3 ADDENDUM 3: 3-WAY STOP REMOVED

5 ADDENDUM 5: EMBANKMENT CLARIFICATIONS

SOLDIER PILE AND LAGGING WALL
ALONG SR-303 WEST OF STATE ROAD

MED-303-13.90/14.96

EMBANKMENT SCHEMATIC IN TYPICAL SGB SECTION:

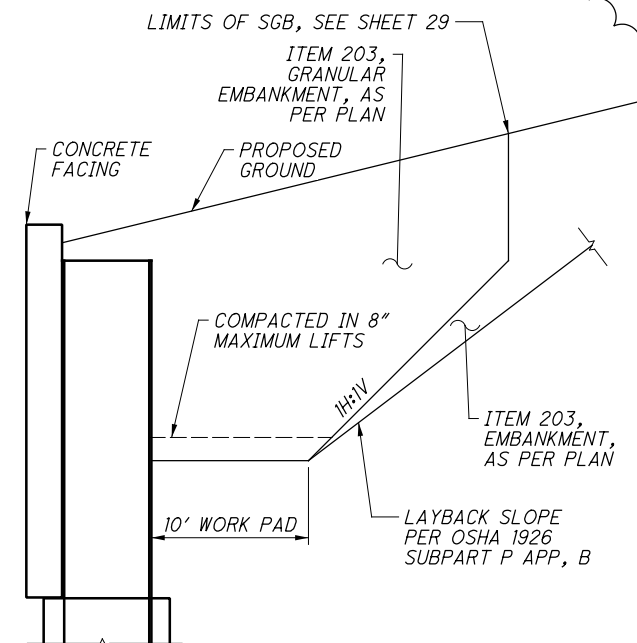
ESTIMATED EMBANKMENT QUANTITIES PROVIDED ARE ASSOCIATED WITH THE LAYBACK SOLUTION SHOWN IN THE PLANS. THE EXACT QUANTITY WILL BE DEPENDENT ON THE CONTRACTOR'S MEANS AND METHODS OF CONSTRUCTION. NO ADDITIONAL PAYMENT SHALL BE MADE FOR QUANTITIES THAT EXCEED THE PLAN VALUES DUE TO CONTRACTOR'S MEANS AND METHODS THAT RESULT IN ADDITIONAL EXCAVATION AND EMBANKMENT. THE CONTRACTOR SHALL SUBMIT TEMPORARY LAYBACK AND BENCHING PLANS FOR APPROVAL PRIOR TO CONSTRUCTION.

THE BACKFILL SHALL CONSIST OF ITEM 203 EMBANKMENT EXCEPT WHERE IT IS NOTED THAT ITEM 203 GRANULAR EMBANKMENT, AS PER PLAN, SHALL BE USED. THE ITEM 203 GRANULAR EMBANKMENT, AS PER PLAN, SHALL BE A SELECT GRANULAR BACKFILL (SGB) AND SHALL CONFORM TO ODOT CMS ITEM 703.11 STRUCTURAL BACKFILL TYPE 2. THE SELECT GRANULAR BACKFILL SHALL BE PLACED BEHIND THE WALL EXTENDING A PERPENDICULAR DISTANCE FROM THE BACKFACE OF THE WALL TO A POINT WHERE A 1H:1V LINE INTERSECTS WITH THE PROPOSED BACK OF WALL GRADE STARTING FROM THE BACKFACE OF THE WALL AT THE "WORK PAD" ELEVATION, AS PER THE GEOTECHNICAL ENGINEERS RECOMMENDATIONS.

OTHER MATERIAL MEETING THE REQUIREMENTS OF ODOT'S ITEM 203 EMBANKMENT CAN BE USED BEYOND THE INDICATED SGB LIMITS. SGB MUST BE SPREAD IN UNIFORM, THIN (8 INCHES OR LESS) LOOSE LIFTS, WITH EACH LIFT COMPACTED TO ACHIEVE A DRY UNIT WEIGHT OF AT LEAST 98 PERCENT OF THE MAXIMUM DRY UNIT WEIGHT, AS DETERMINED IN THE LABORATORY BY THE "STANDARD METHOD OF TEST FOR MOISTURE DENSITY RELATIONS OF SOILS USING A 5.5-LB RAMMER AND A 12-IN. DROP" (AASHTO T 99 METHOD C). SGB SHOULD BE MOISTURE CONDITIONED (AS NEEDED) TO MAINTAIN THE MOISTURE CONTENT OF THE FILL MATERIAL WITHIN 2 PERCENTAGE POINTS OF THE OPTIMUM MOISTURE CONTENT. WITHIN 3 FEET OF THE FACING PANELS (TIMBER LAGGING) COMPACT THE SGB WITH AT LEAST SIX PASSES OF A LIGHT MECHANICAL TAMPER WEIGHTING BETWEEN 1/2 TO 2 TONS.

ESTIMATED EMBANKMENT QUANTITIES PROVIDED ARE ASSOCIATED WITH THE LAYBACK SOLUTION SHOWN IN THE PLANS. THE EXACT QUANTITY WILL BE DEPENDENT ON THE CONTRACTOR'S MEANS AND METHODS OF CONSTRUCTION. NO ADDITIONAL PAYMENT SHALL BE MADE FOR QUANTITIES THAT EXCEED THE PLAN VALUES DUE TO CONTRACTOR'S MEANS AND METHODS THAT RESULT IN ADDITIONAL EXCAVATION AND EMBANKMENT. THE CONTRACTOR SHALL SUBMIT TEMPORARY LAYBACK AND BENCHING PLANS FOR APPROVAL PRIOR TO CONSTRUCTION.

ADDENDUM 5: EMBANKMENT CLARIFICATIONS

WALL PLAN
 SOLDIER PILE AND LAGGING WALL
 ALONG SR-303 WEST OF STATE ROAD

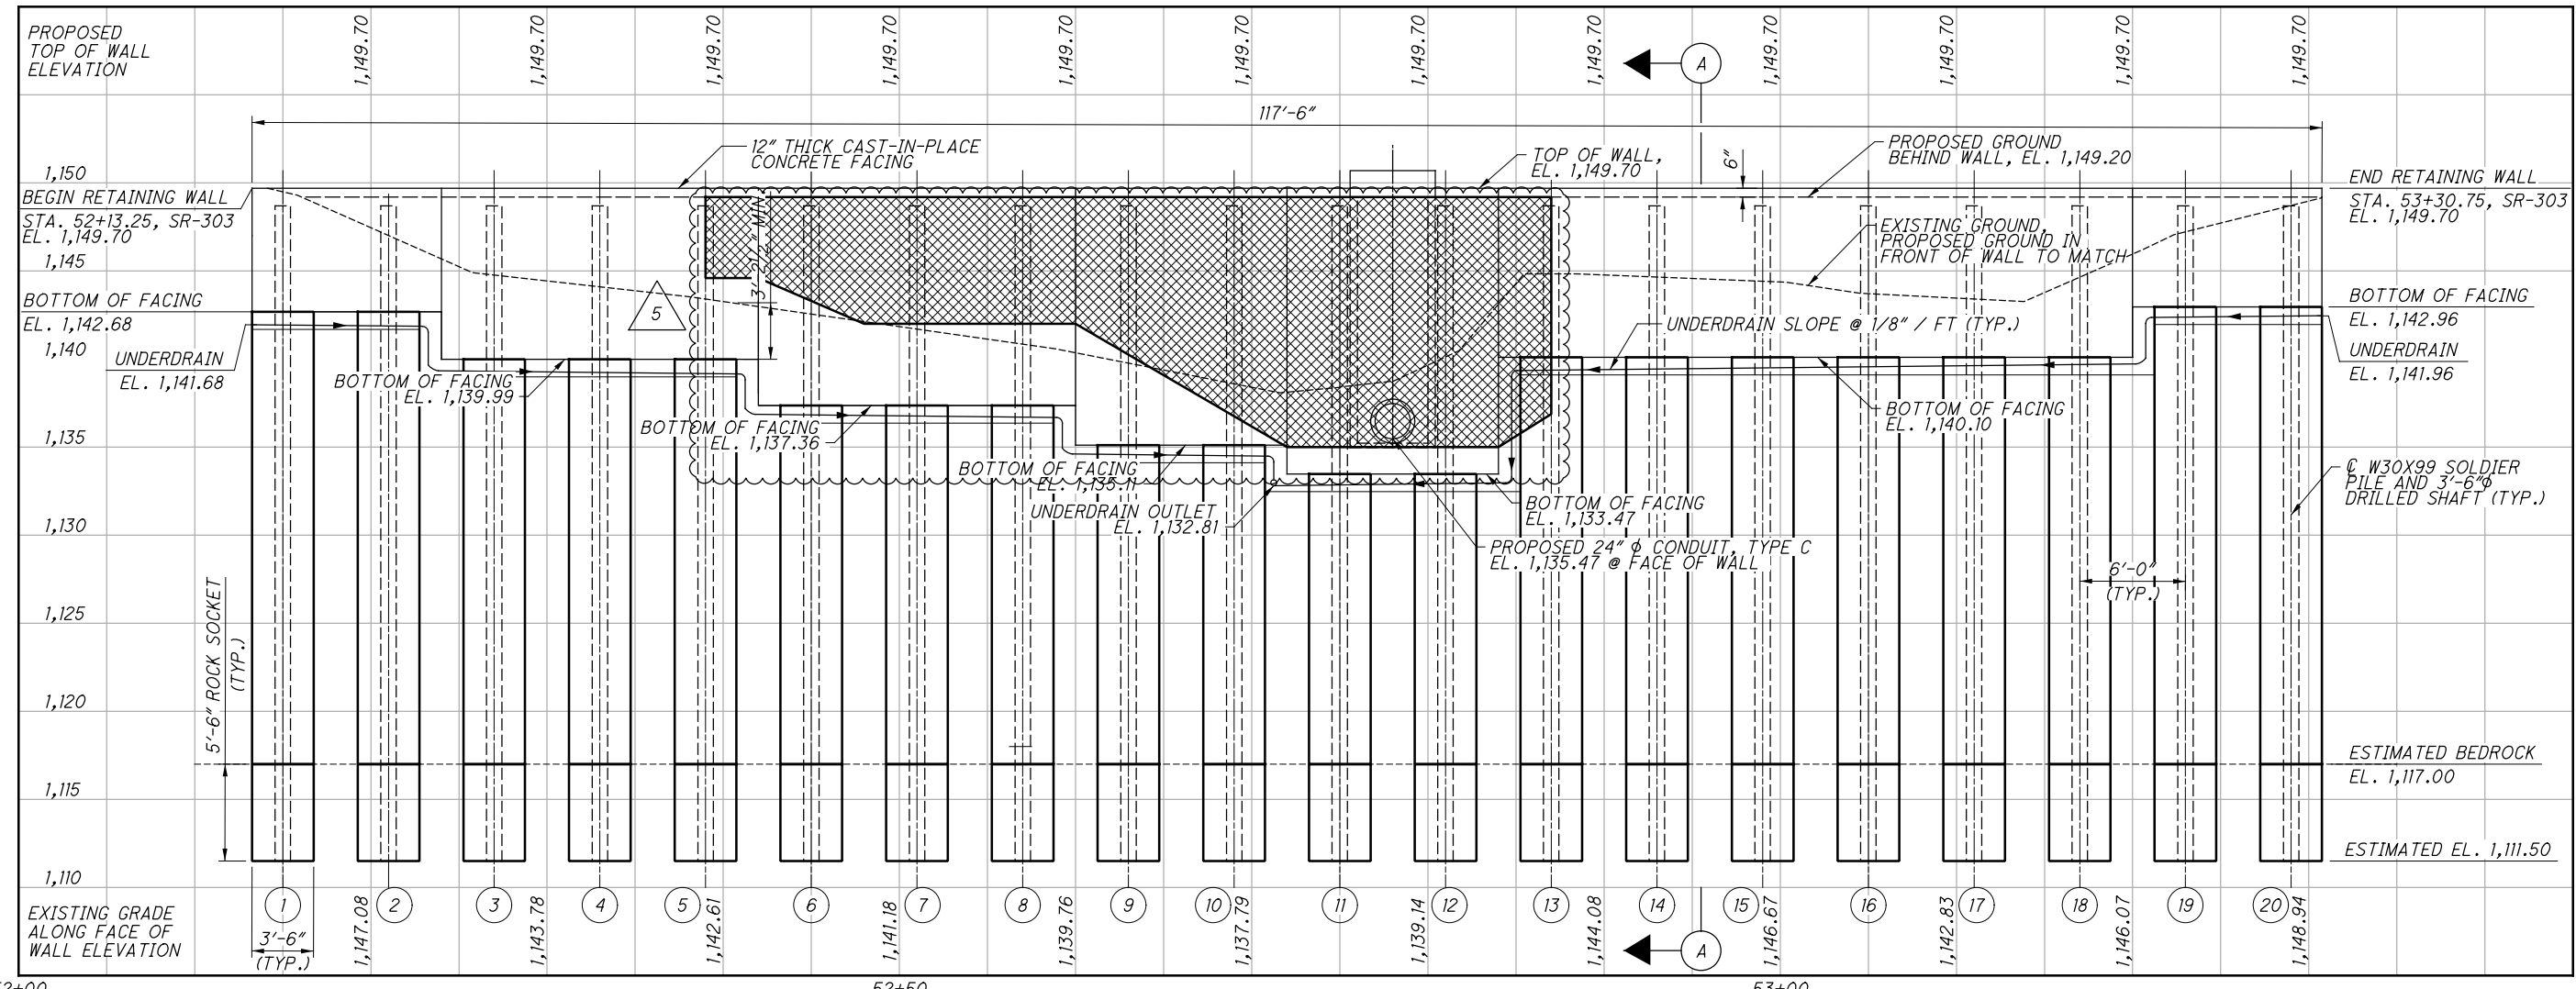
- NOTES:**
1. FOR WALL ELEVATION, SEE SHEET 5/8.
 2. FOR WALL DETAILS, SEE SHEET 7/8.
 3. BACKFILL OF THE RETAINING WALL SHALL BE PLACED PRIOR TO CONSTRUCTING THE CAST-IN-PLACE FACING. THE BACKFILL SHALL CONSIST OF ITEM 203 EMBANKMENT, AS PER PLAN EXCEPT WHERE IT IS NOTED THAT ITEM 203 GRANULAR EMBANKMENT, AS PER PLAN, SHALL BE USED. THE ITEM 203 GRANULAR EMBANKMENT, AS PER PLAN, SHALL BE A SELECT GRANULAR BACKFILL AND SHALL CONFORM TO ODOT CMS ITEM 703.11 STRUCTURAL BACKFILL TYPE 2. THE SELECT GRANULAR BACKFILL SHALL EXTEND FROM THE BASE OF THE WALL TO THE INTERSECTING PROPOSED GRADE LINE AND TO THE BOTTOM OF THE EXCAVATION. SEE NOTE ON SHEET 26.

5 ADDENDUM 5: EMBANKMENT CLARIFICATIONS

ELEVATION ALONG FACE OF WALL

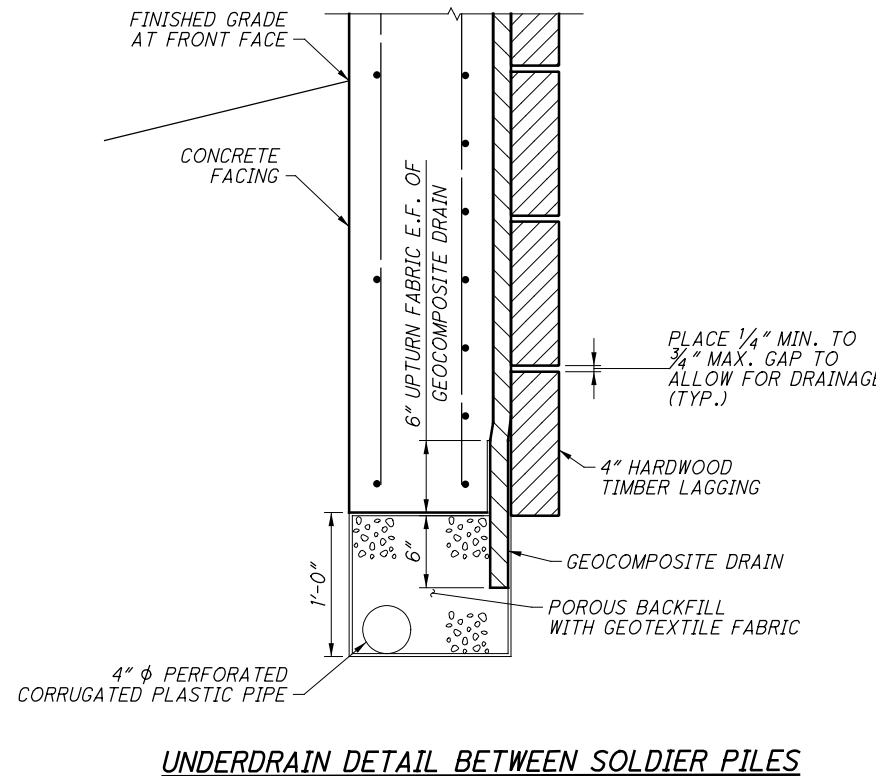
- (X) PILE NUMBER
- 5 - ITEM 203: GRANULAR EMBANKMENT, AS PER PLAN (SELECT GRANULAR BACKFILL)

5 ADDENDUM 5: EMBANKMENT CLARIFICATIONS

SECTION A-A

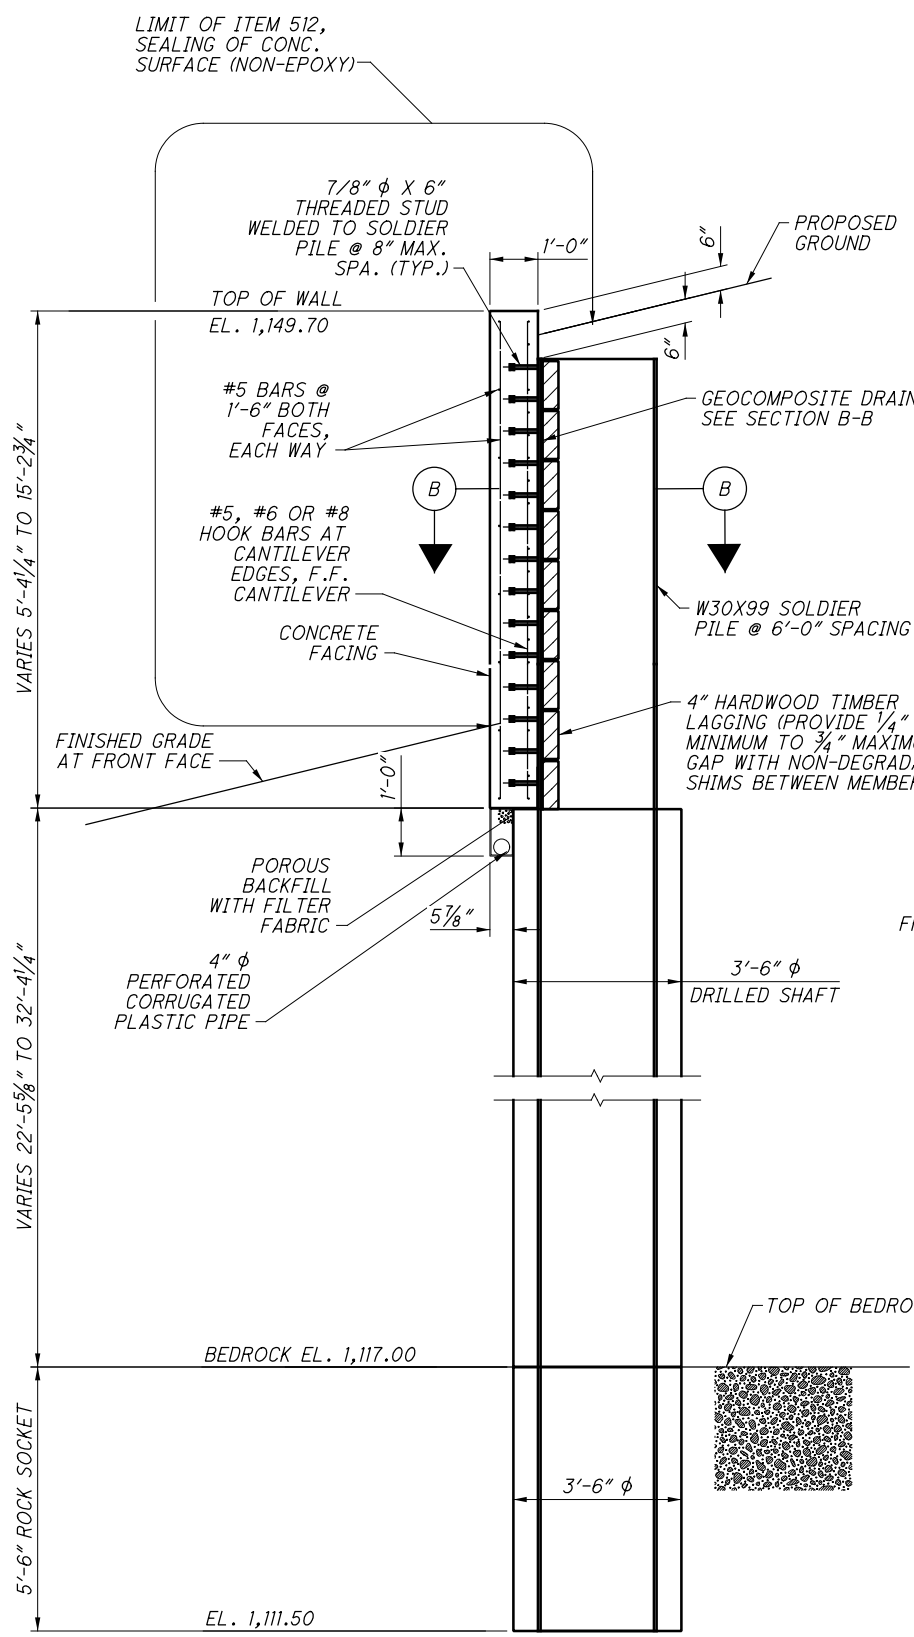
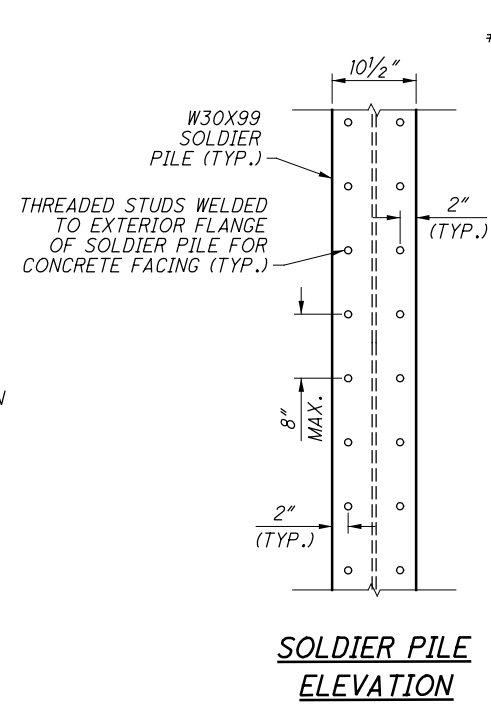
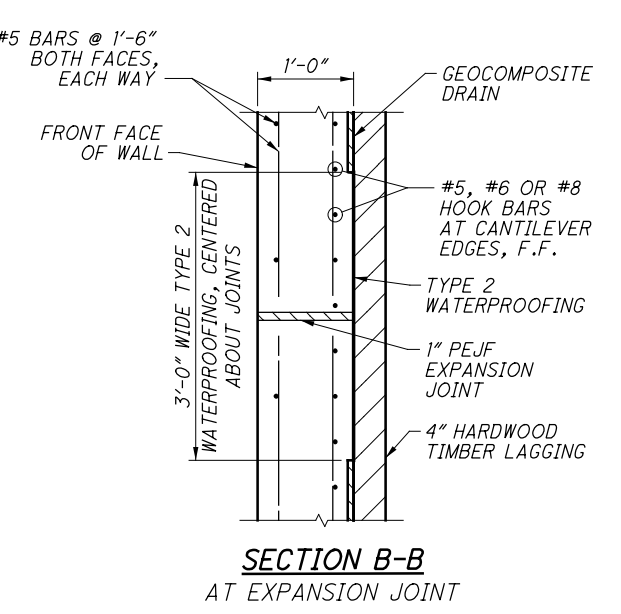
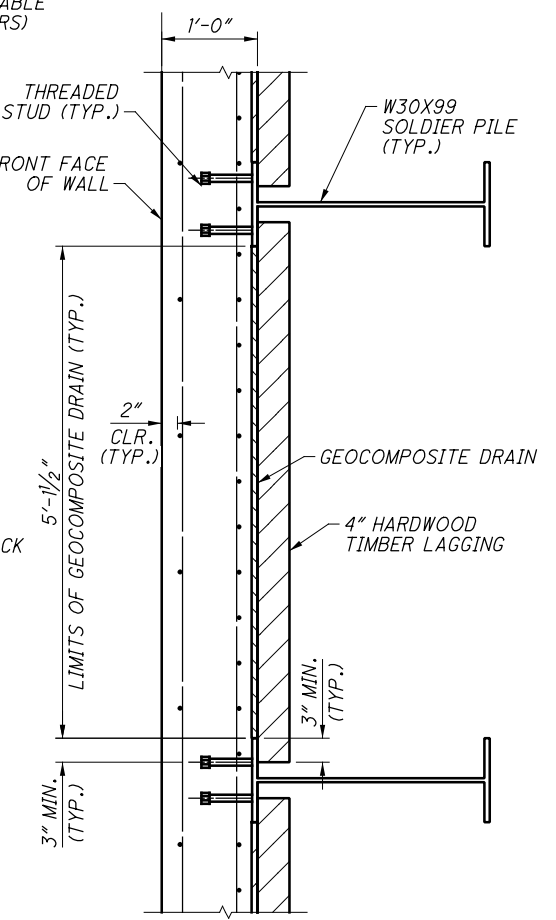
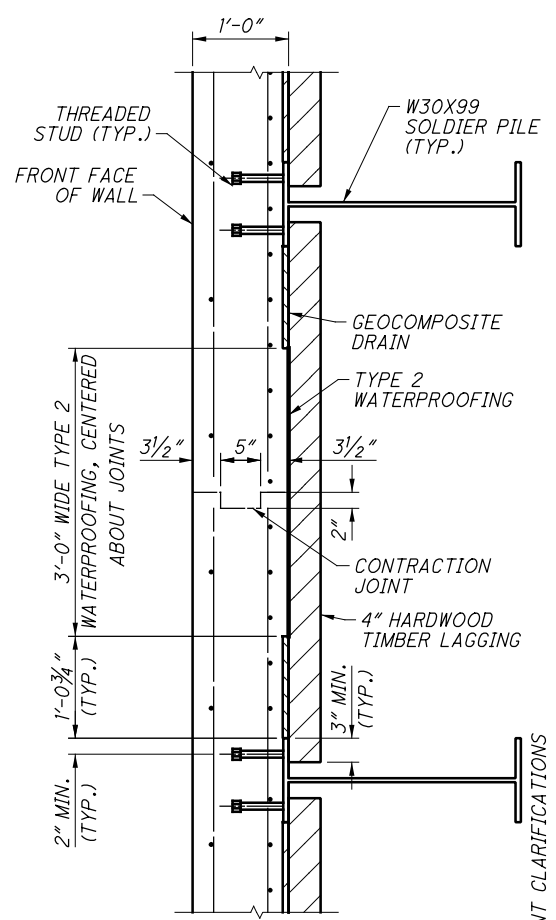
1. FOR WALL PLAN, SEE SHEET 4/8.
2. FOR WALL ELEVATION, SEE SHEET 5/8.
3. STUDS INCLUDED IN PRICE OF ITEM 507 - STEEL PILES, MISC.: SOLDIER PILES.
4. FOR LOCATION OF SECTION A-A, SEE SHEET 5/8.
5. BACKFILL RETAINING WALL WITH ITEM 203 - EMBANKMENT, AS PER PLAN.
6. EXCEPT WHERE NOTED TO USE ITEM 203 - GRANULAR EMBANKMENT, AS PER PLAN.
7. BACKFILL MUST BE COMPLETED PRIOR TO INSTALLING THE CIP WALL FACING.

DESIGN AGENCY DLN, Inc. 2475 Sugar Grove Rd., SE Lancaster, Ohio 43130 (740) 687-5542 Phone - (740) 687-0066 Fax	DATE 9/19/19	STRUCTURE FILE NUMBER
DRAWN JBM	REVISIONS JBM REVISED	REVIEWED MUR	DATE 9/19/19
DESIGNED JBM	CHECKED JAH	WALL TYPICAL SECTION SOLDIER PILE AND LAGGING WALL ALONG SR-303 WEST OF STATE ROAD	
MED-303-13.90/14.96		PID No. 94440	
APPENDUM 5: EMBANKMENT CLARIFICATIONS			
7/8			
32 60
